Date: Aug 07, 2000

From: George Penokie (IBM)

Subject: Defining Targets/Initiators as Ports

What follows are suggested changes to SAM that would define targets and initiators as ports and allow multiples on a single SCSI device.

Figure 4 - Basic SCSI hierarchy

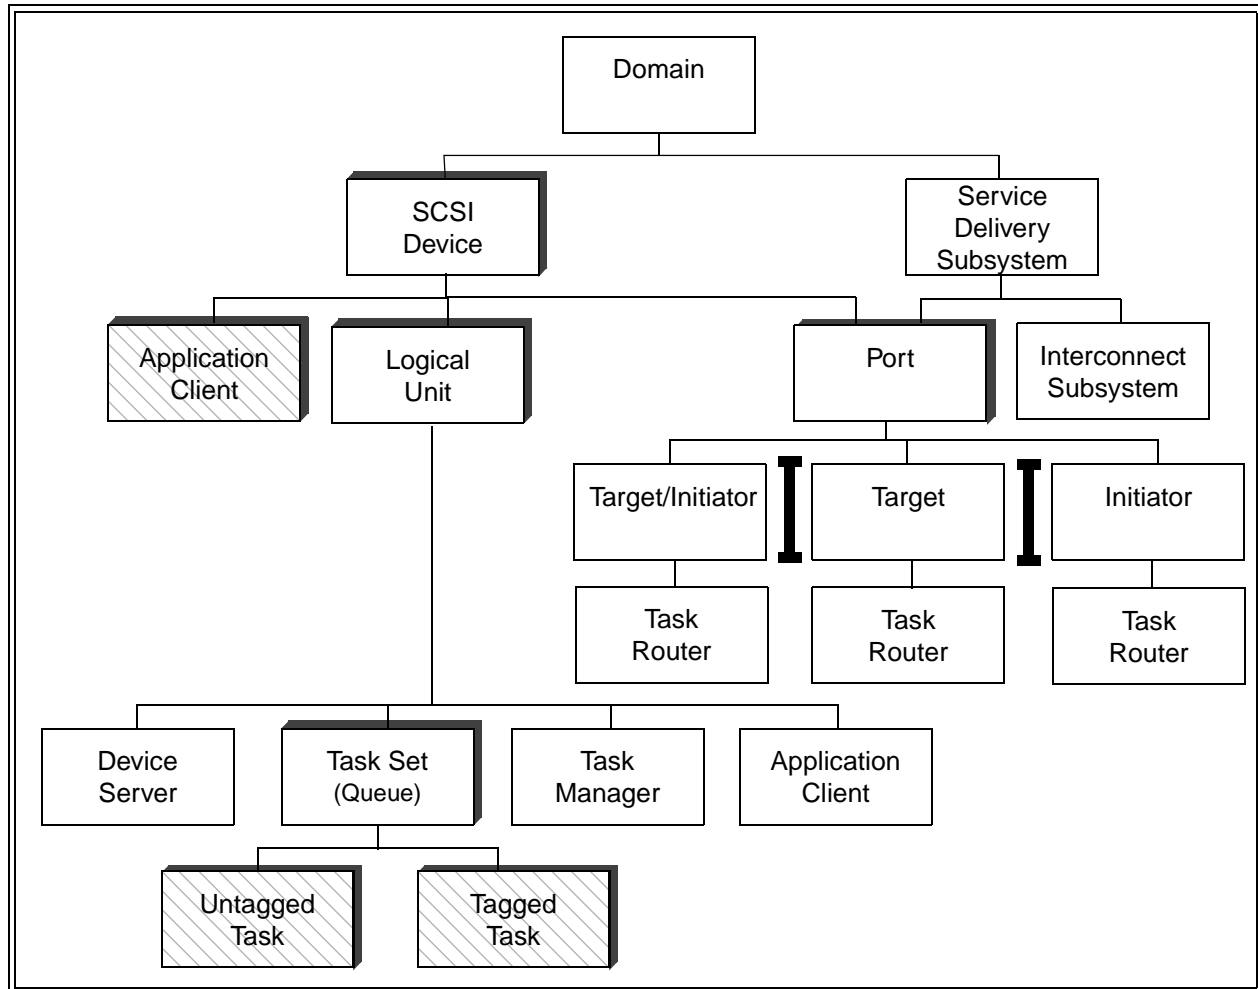
The following show the changes to figures in section 4 of SAM-2 that would be required to change to support a port = target/initiator model.

Figure 4 shows the main functional components of the basic SCSI hierarchy. The following clauses define these components in greater detail.

Figure 5 - SCSI Device hierarchy diagram

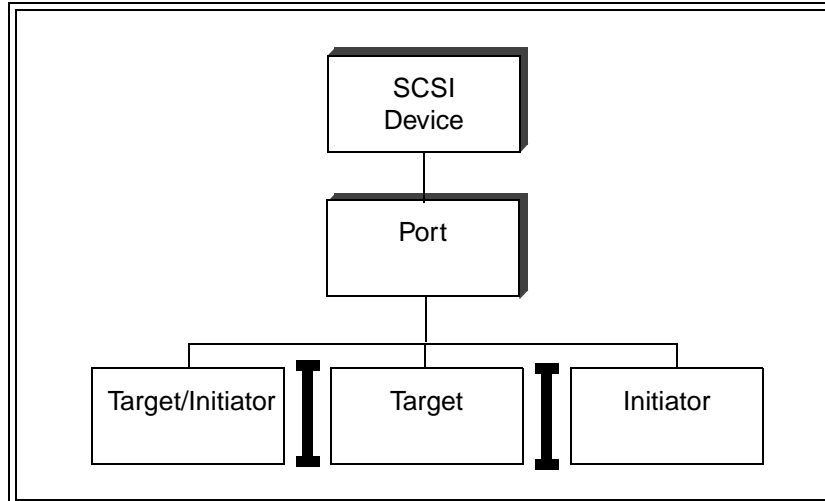
In the basic structural model, a SCSI device (see figure 5) is composed of one or more ports (see 4.6) each of which is a target, initiator, or target/initiator.

Figure 6 - SCSI device functional models

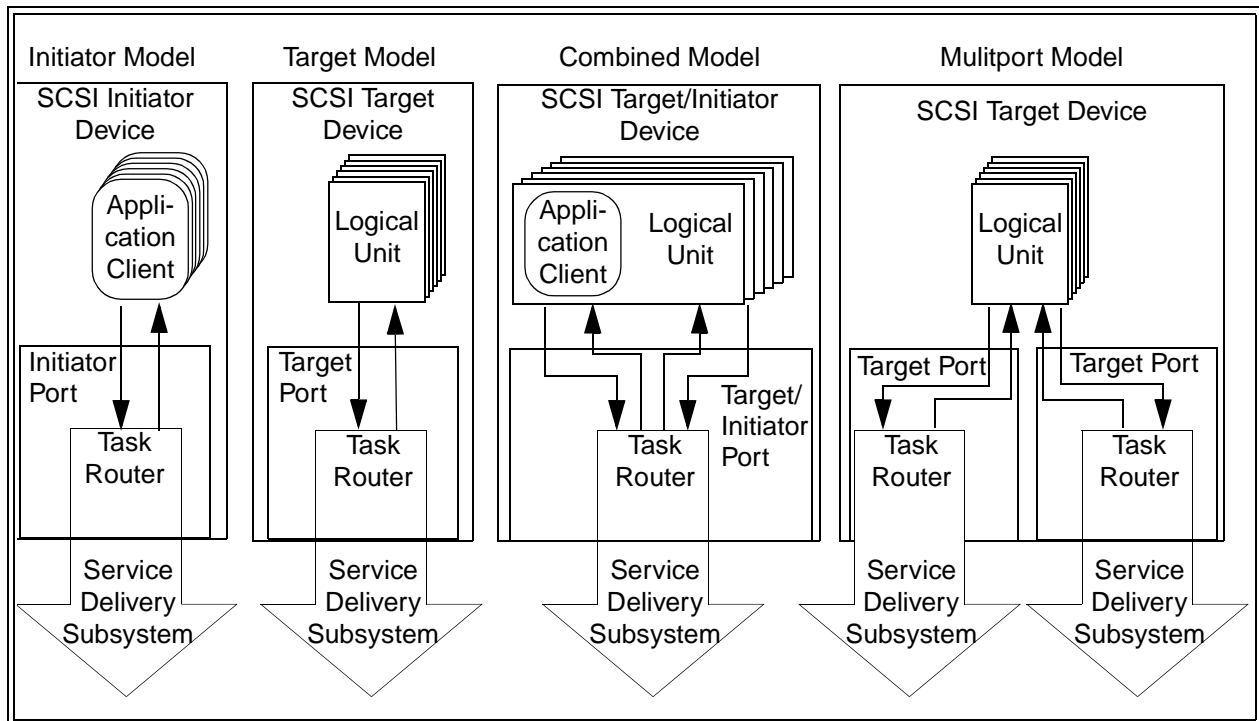
There are several models for implementing ports in an SCSI device, some are shown in figure 6. An SCSI device may contain only target ports, only initiator ports, only target/initiator ports or any combination there of.

Figure 7 - Initiator hierarchy diagram

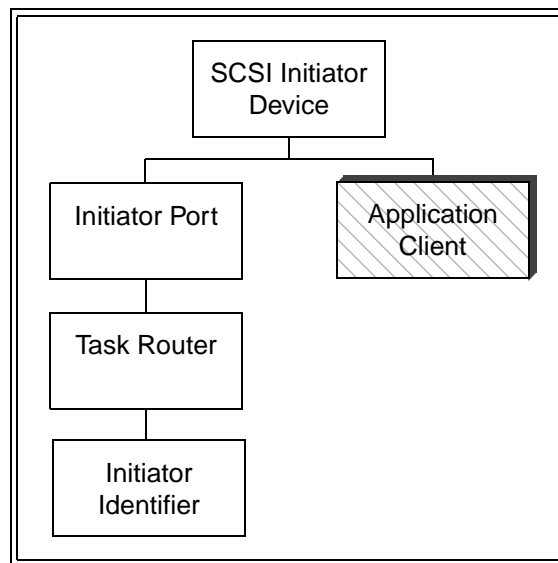
A SCSI initiator device (see figure 7) is composed of a task router and an Initiator Identifier for each initiator port and zero or more application clients.

Figure 8 - Target hierarchy diagram

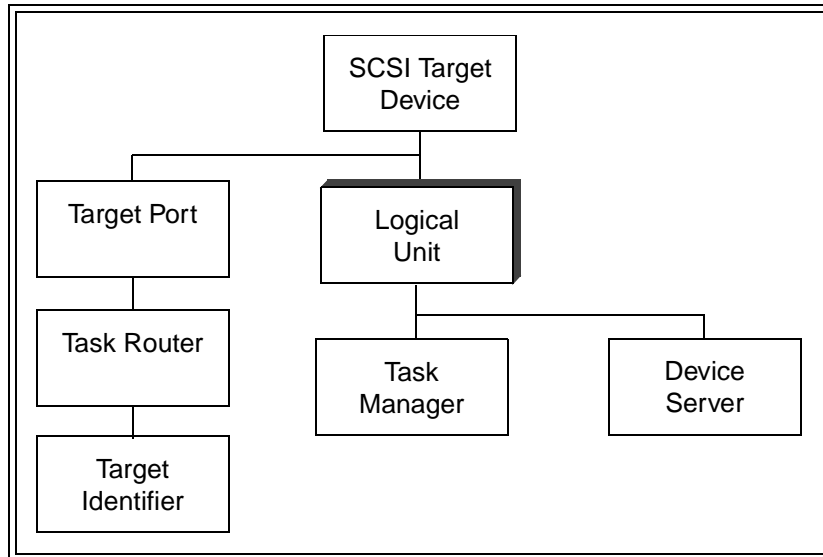
A SCSI target device (see figure 8) is composed of a task router and target identifier for each target port and one or more logical units composed of a task manager and a device server.

Figure 9 - Target hierarchy diagram

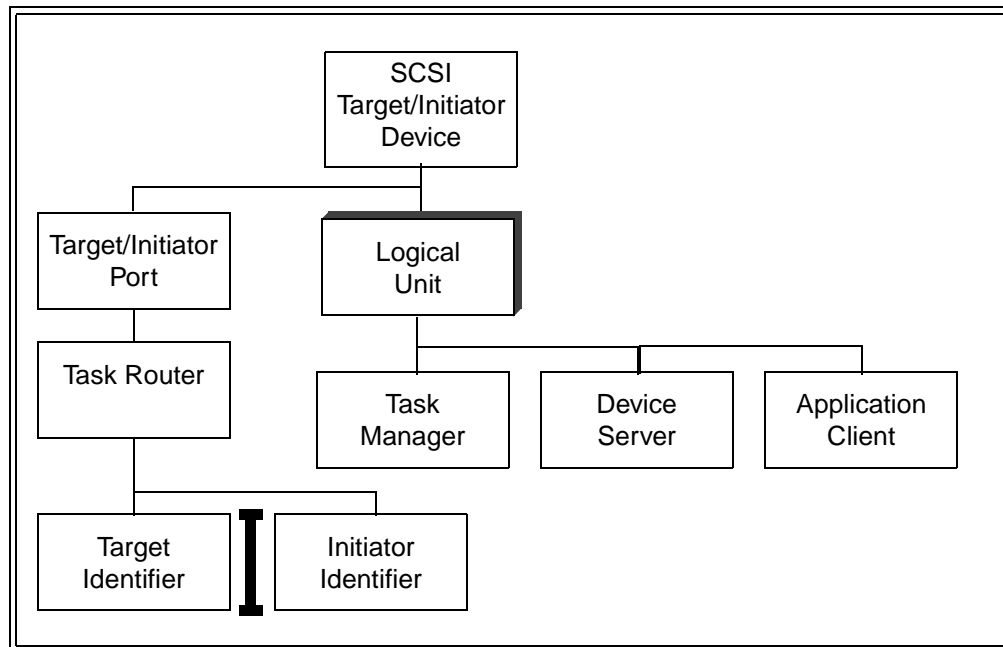
A SCSI target/initiator device (see figure 8) is composed of a task router and target identifier or initiator identifier for each target/initiator port and one or more logical units composed of a task manager, application client, and a device server.

Figure 10 - A SCSI multi-port unit and multiple SCSI domains

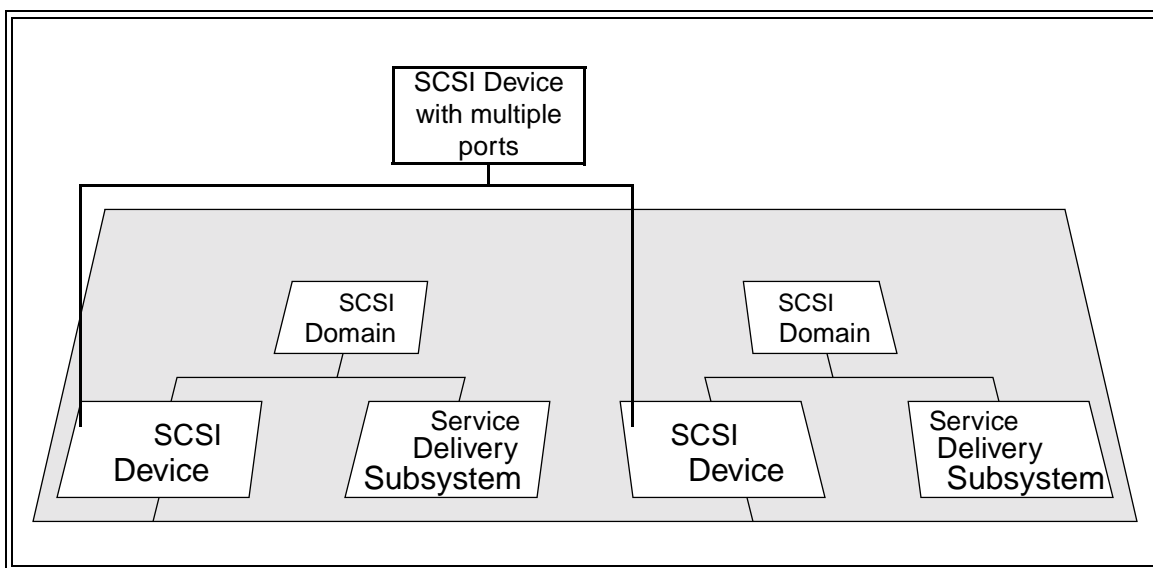
SCSI devices with multiple ports do not fit in the two dimensional hierarchy shown in 4.4. Instead, they combine basic objects from the SCSI device model in a way that produces a different structural plane. Figure 10 also shows that SCSI devices from different domains may be connected to a single SCSI device with multiple ports.

Figure 11 - Multiple port target SCSI device structure model

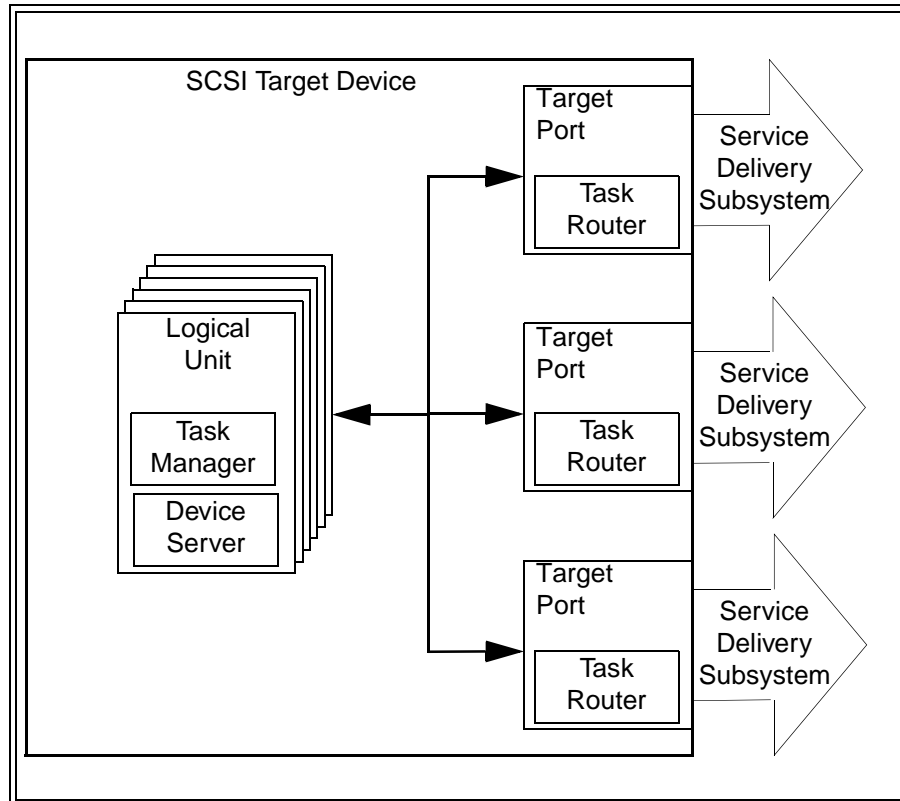
Figure 10 shows the structure of a SCSI target device with multiple target ports. Each target port consists of a task router and is shared by a collection of logical units. Each logical unit contains a single task manager and a device server.

Figure 12 - Multiple port SCSI initiator device structure model

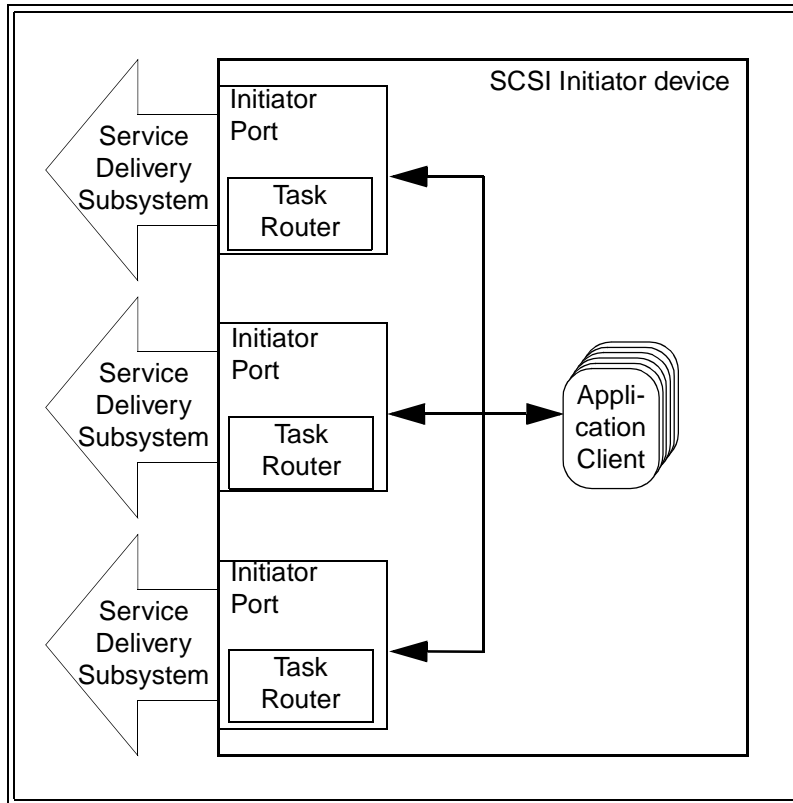
Figure 11 shows the structure of a SCSI initiator device with multiple initiator ports. Each initiator port consists of a task router and is shared by a collection of application clients.

Figure 13 - Multiple port target/initiator SCSI device structure model

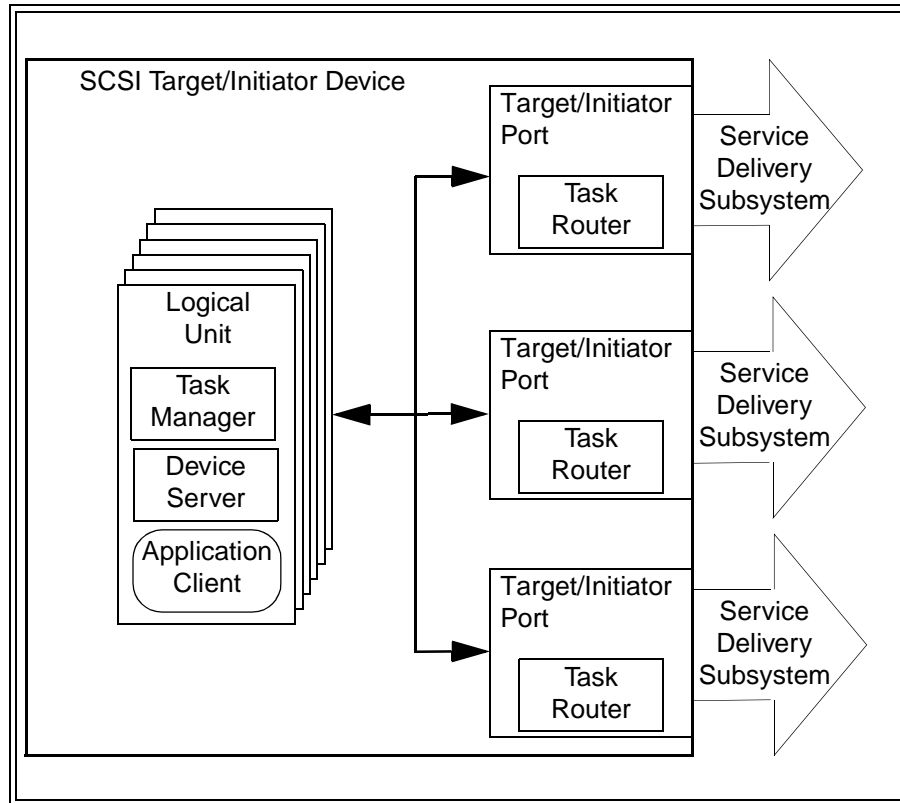
Figure 13 shows the structure of a SCSI target/initiator device with multiple target/initiator ports. Each target/initiator port consists of a task router and is shared by a collection of logical units. Each logical unit contains a single task manager, a device server, and an application client.

Figure 14 - SCSI target device configured in a single SCSI Domain

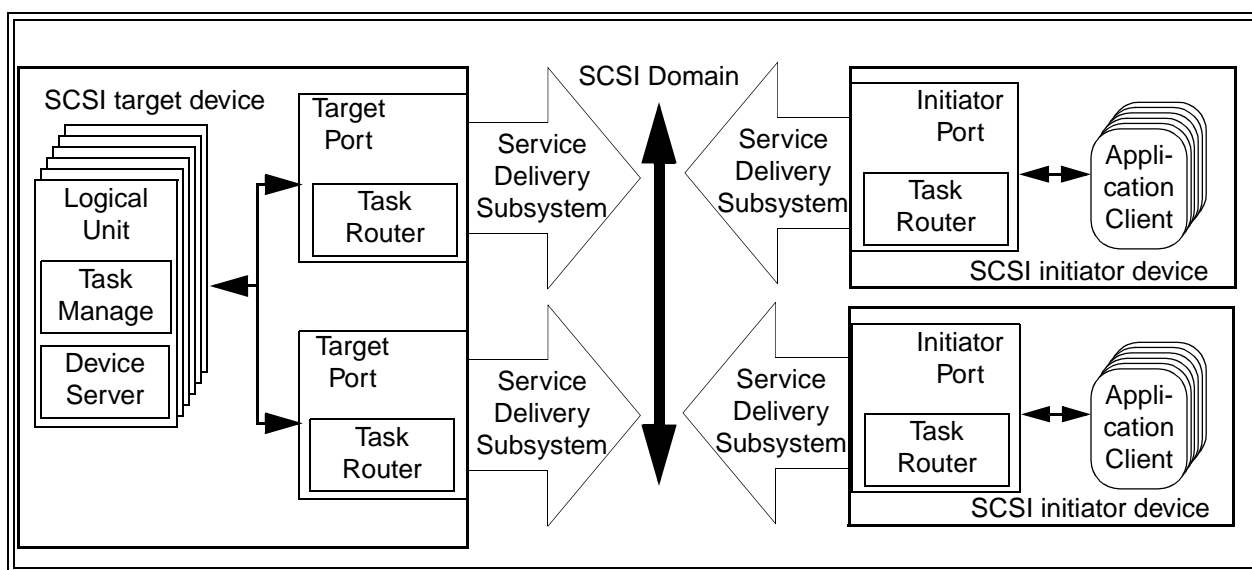
Figure 14 shows a SCSI target device with multiple target ports participating in a single SCSI Domain with two SCSI initiator devices. There are three SCSI devices, one of which has two target ports, one with one initiator port, and one with one initiator port. There are two Target Identifiers and two Initiator Identifiers in this SCSI Domain. Using the INQUIRY command Vital Product Data page as described in xxx, the application clients in each of the SCSI initiator devices that have the ability to discover the logical units in the SCSI target devices are accessible via multiple Target Identifiers (target ports) and map the configuration of the SCSI target devices.

Figure 15 - SCSI target device configured in multiple SCSI Domains

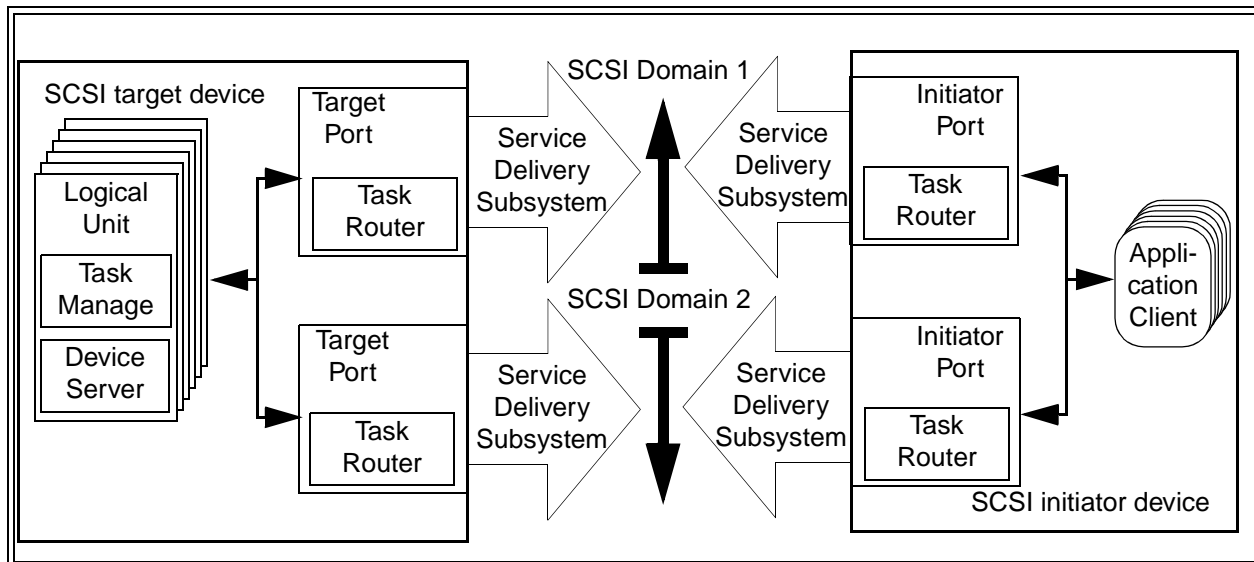
Figure 15 shows a SCSI target device with multiple target ports participating in two SCSI Domains and a SCSI initiator device with multiple initiator ports participating in the same two SCSI Domains. There is one SCSI target device two target ports and the a SCSI initiator device with two initiator ports. There is one Target Identifier and one Initiator Identifier in each of the two SCSI Domains. Using the INQUIRY command Vital Product Data page as described in xxx, the application clients in the SCSI initiator device have the ability to discover that logical units in the SCSI target device are accessible via multiple ports and map the configuration. However, the methods available to application clients to distinguish between the configuration shown in figure 15 and the configuration shown in figure 22 may be beyond the scope of the SCSI family of standards.

Figure 16 - SCSI target device and SCSI initiator device configured in a single SCSI Domain

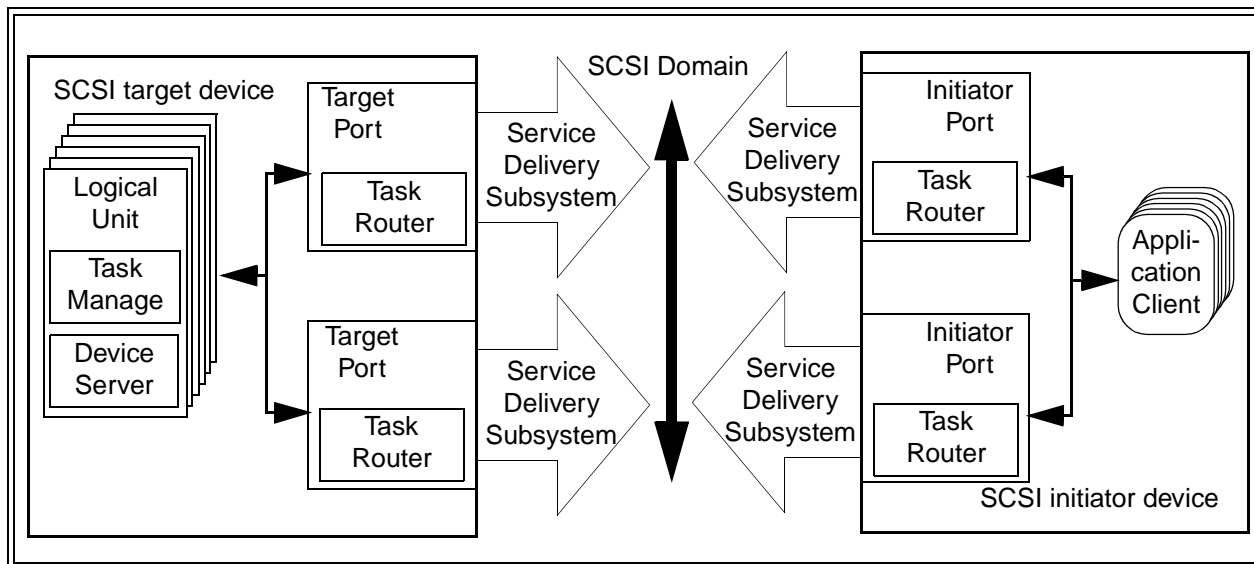
Figure 16 shows the same configuration as figure 15 except that the two SCSI Domains have been replaced by a single SCSI Domain.
